Re: VCP Project #13CVCP094K – 81 Fleet Place
Remedial Action Work Plan (RAWP) Stipulation List

Galli Engineering, P.C. (Galli) hereby submits a Remedial Action Work Plan (RAWP) Stipulation List for the subject site to the New York City Office of Environmental Remediation (NYC OER) on behalf of RA Real Estate, LLC. This letter serves as an addendum to the RAWP to stipulate additional content, requirements and procedures that will be followed during the site remediation. The contents of this list are added to the RAWP and will supersede the content in the RAWP where there is a conflict in purpose or intent. The additional requirements/procedures include the following:

Stipulation List

OUTBOUND TRUCK ROUTE MAP

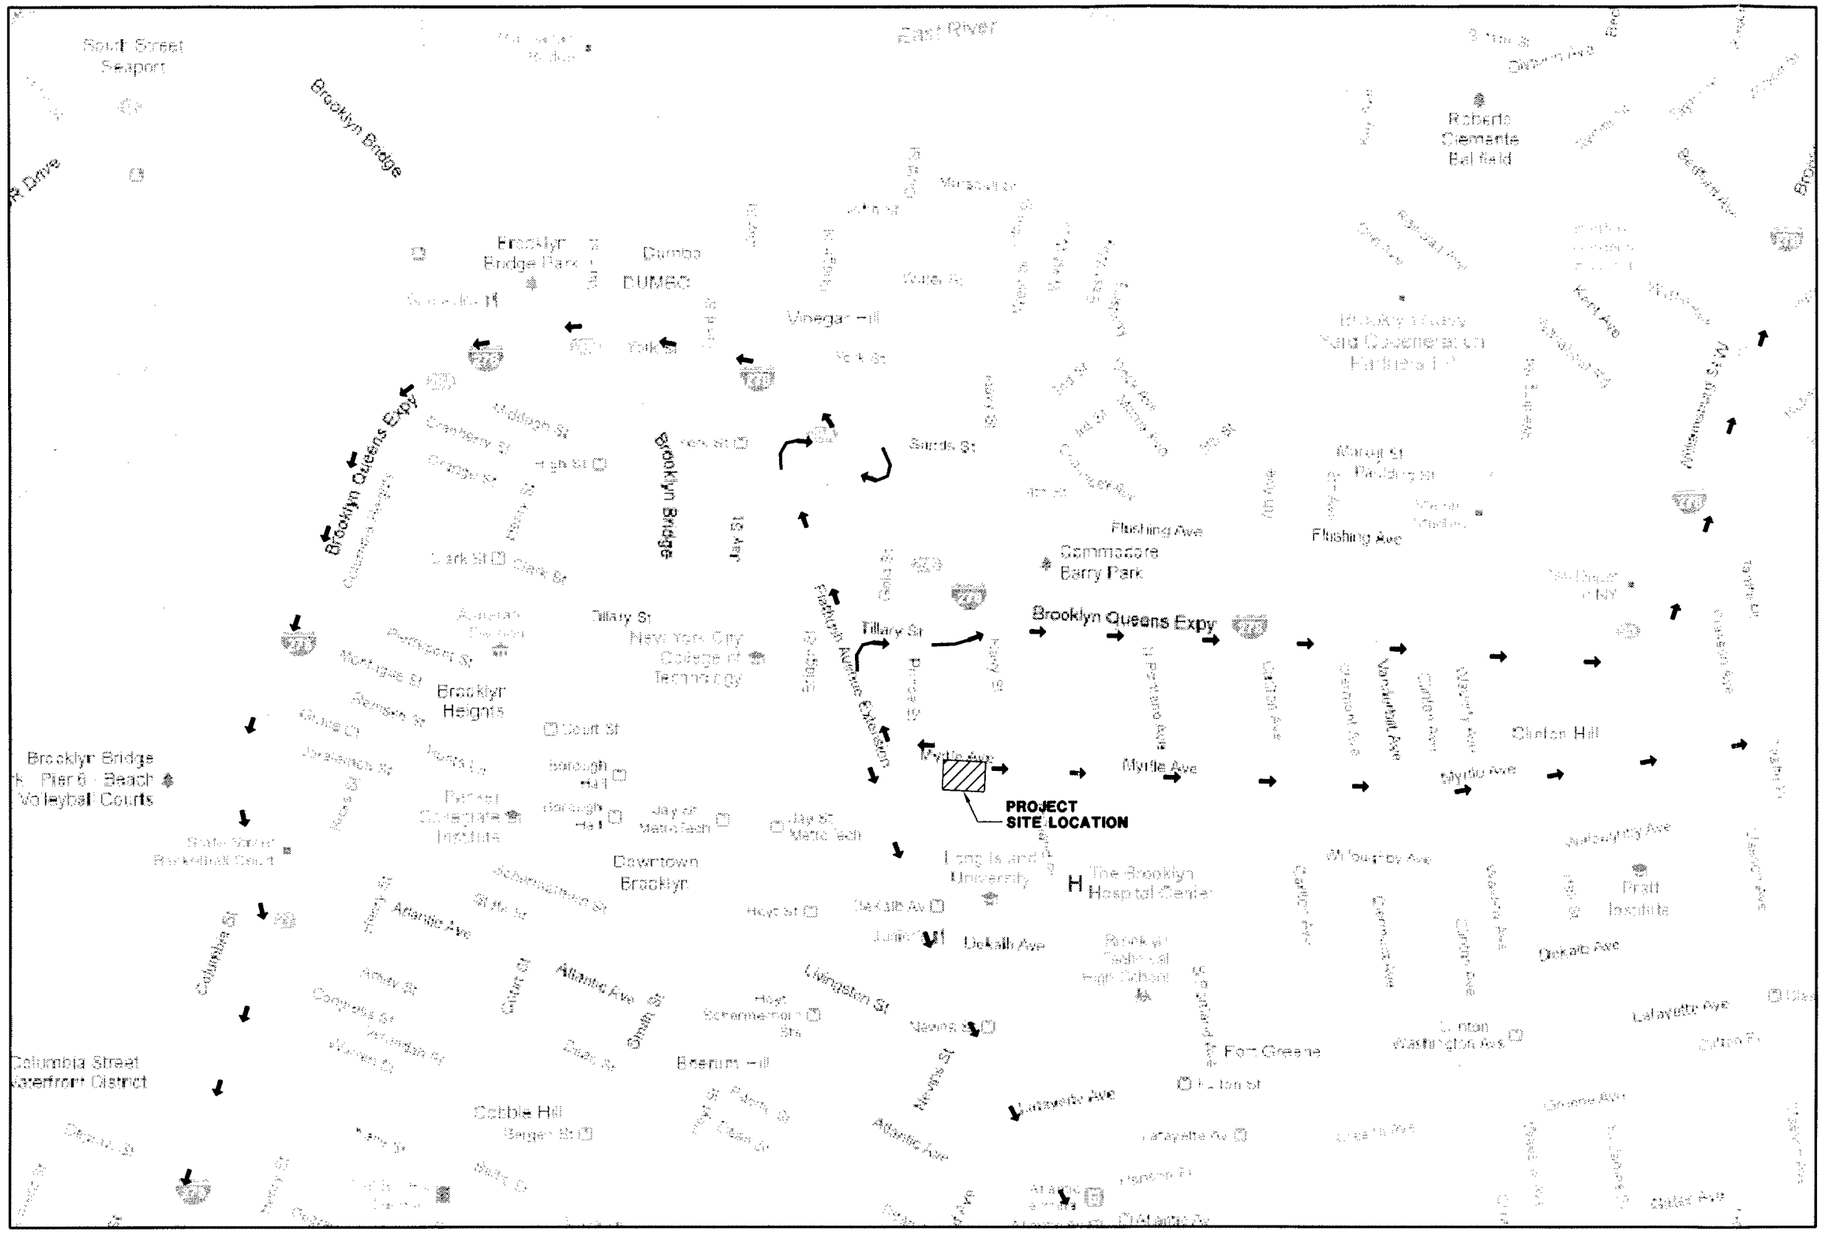
3. An outbound truck transport route is attached in **Appendix 2**.

SOIL REUSE ON-SITE DIAGRAM

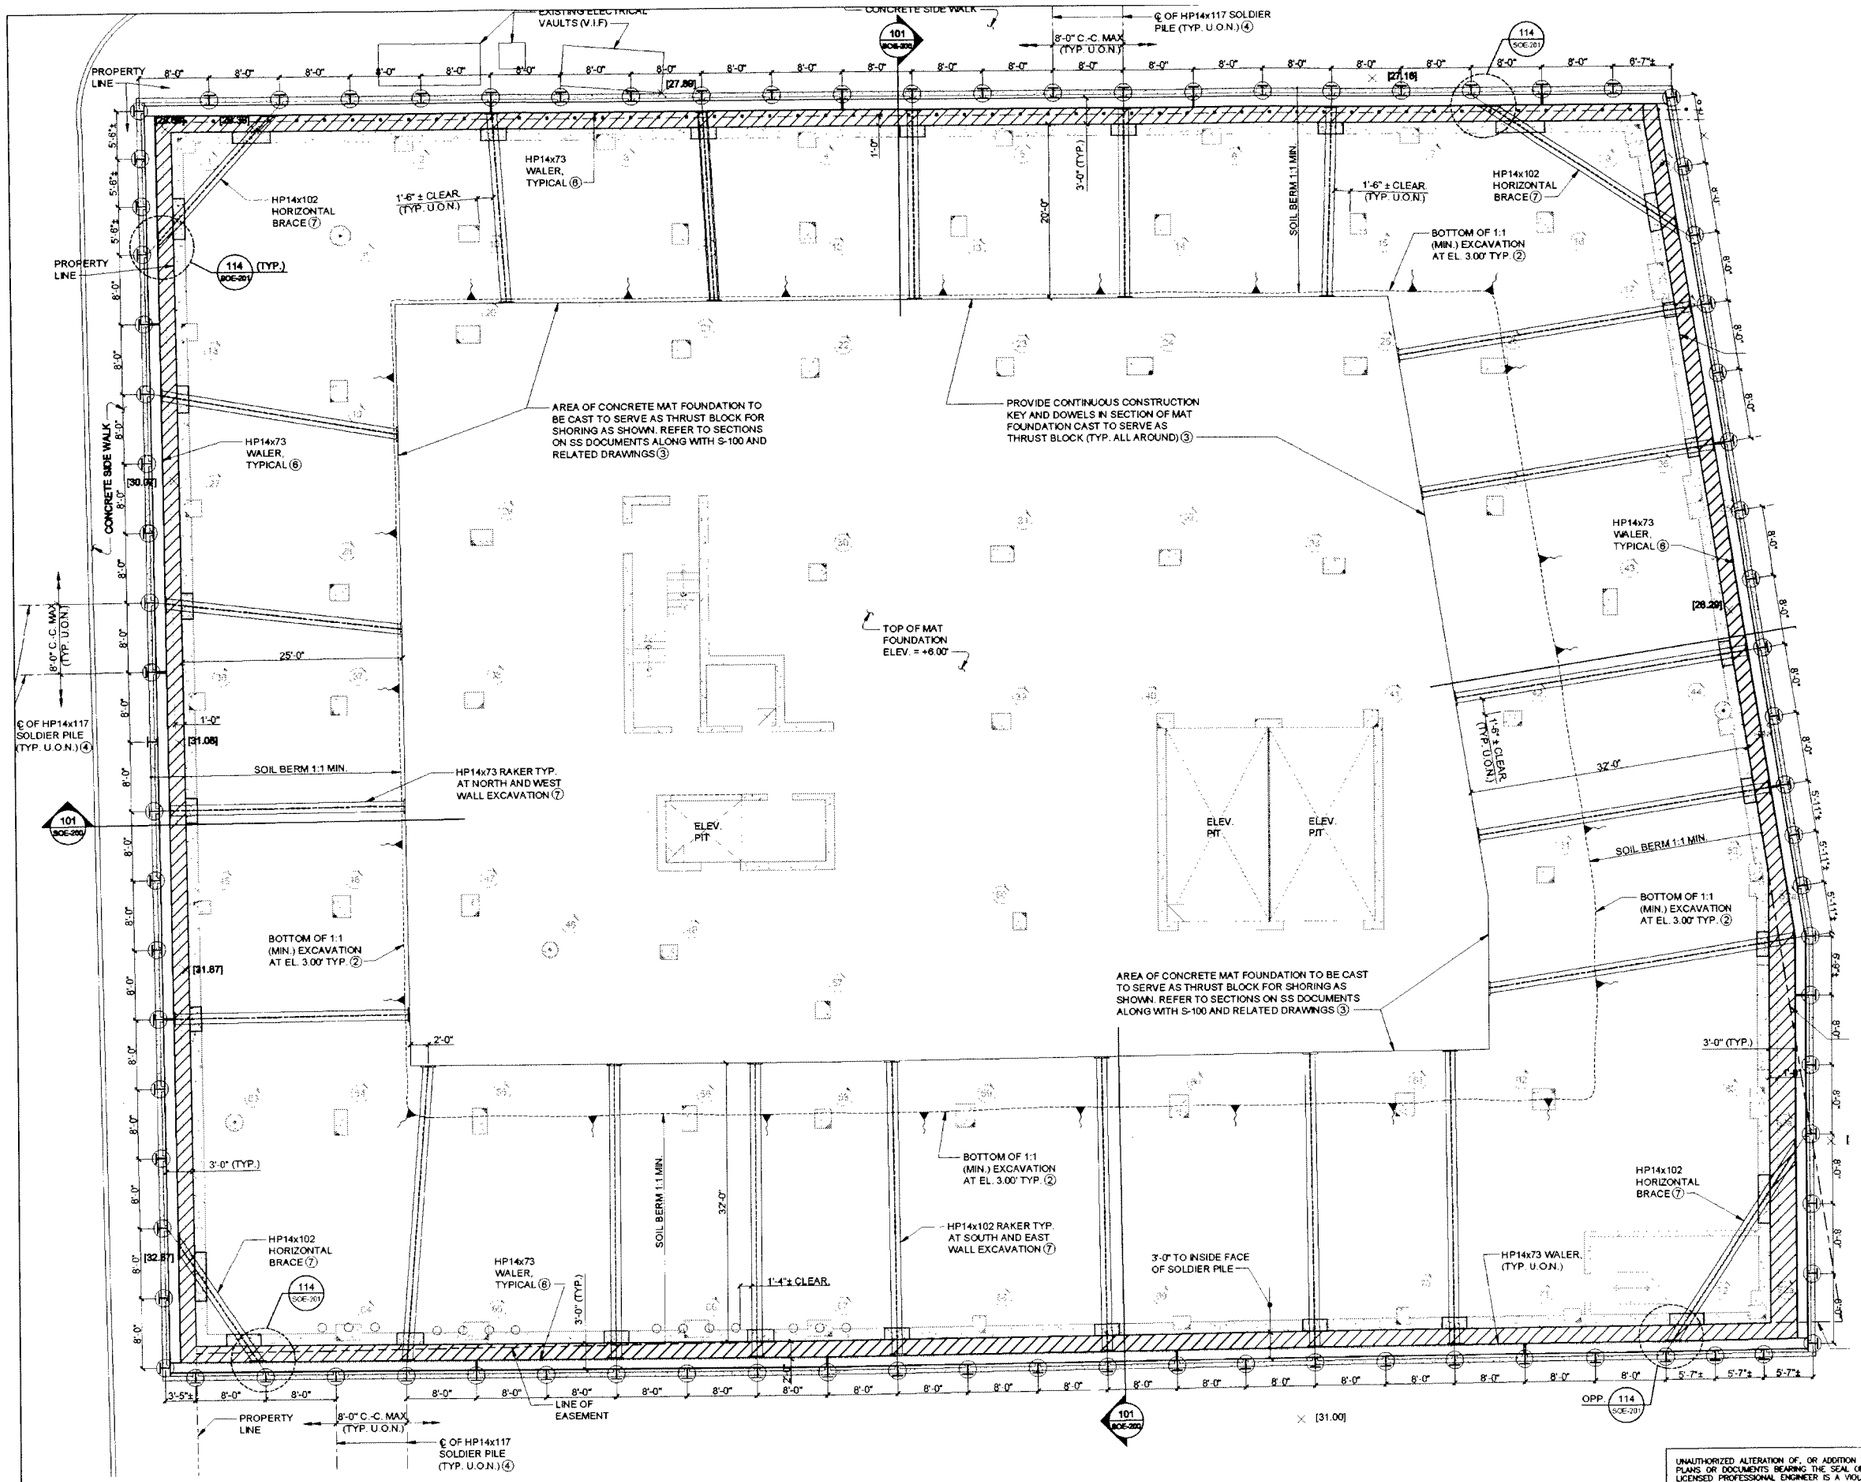
4. A soil reuse on-site location diagram is attached in **Appendix 3**.

PROPOSED MONITORING WELL LOCATIONS PLAN

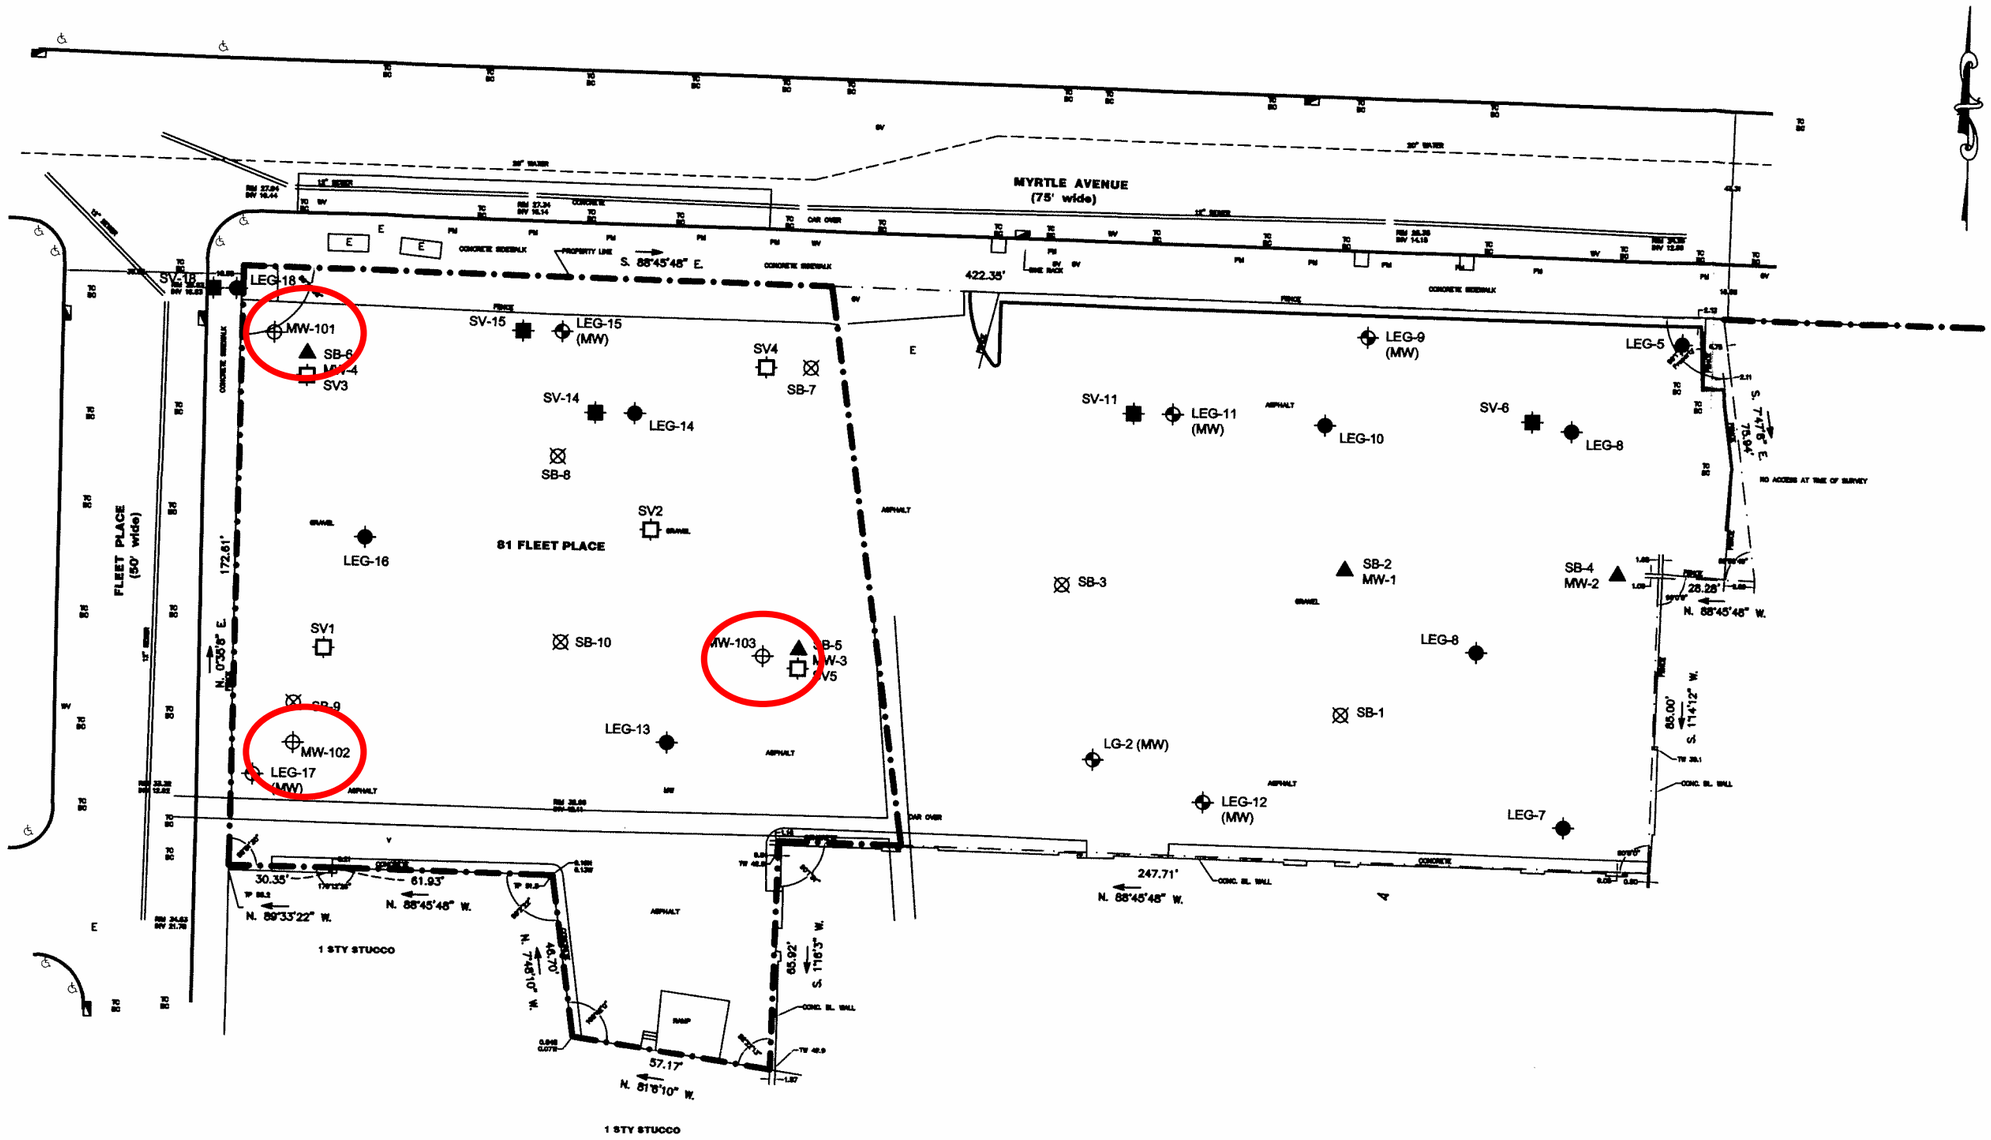
8. Additional groundwater investigation will be conducted prior to excavation. A sampling plan is attached in **Appendix 5**.

Three additional monitoring wells, to replace the original destroyed wells, will be installed at approximately the locations shown on the attached site sketch. This arrangement allows for triangulation to calculate local groundwater flow direction and coverage near hot spots associated with high metals and chlorinated solvent concentrations in previous groundwater samples.
